**BLDC Water Wastewater Infrastructure Program
Tender Package # 5C.1 – Potable & Reclaimed Water Reservoir Transfer Networks – Pumps & Controls**

Addendum Two

Attachment 1- Answers and Clarification Document- Addendum 2

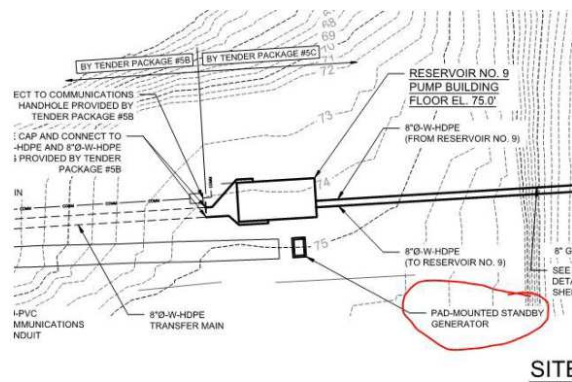
15. Res No 9 E504 – C5404. The one-line drawings says the generator feeders shall be trenched to RES 9. Is this correct because it seems like a long distance to trench for a small generator.

The above sketch shows the location of the generator. This is a very close run to the Res 9 pump room. The one line on E5404 incorrectly states Res 3. This should state Res 9.

BLDC Answer: Follow the direction of the Designer above.
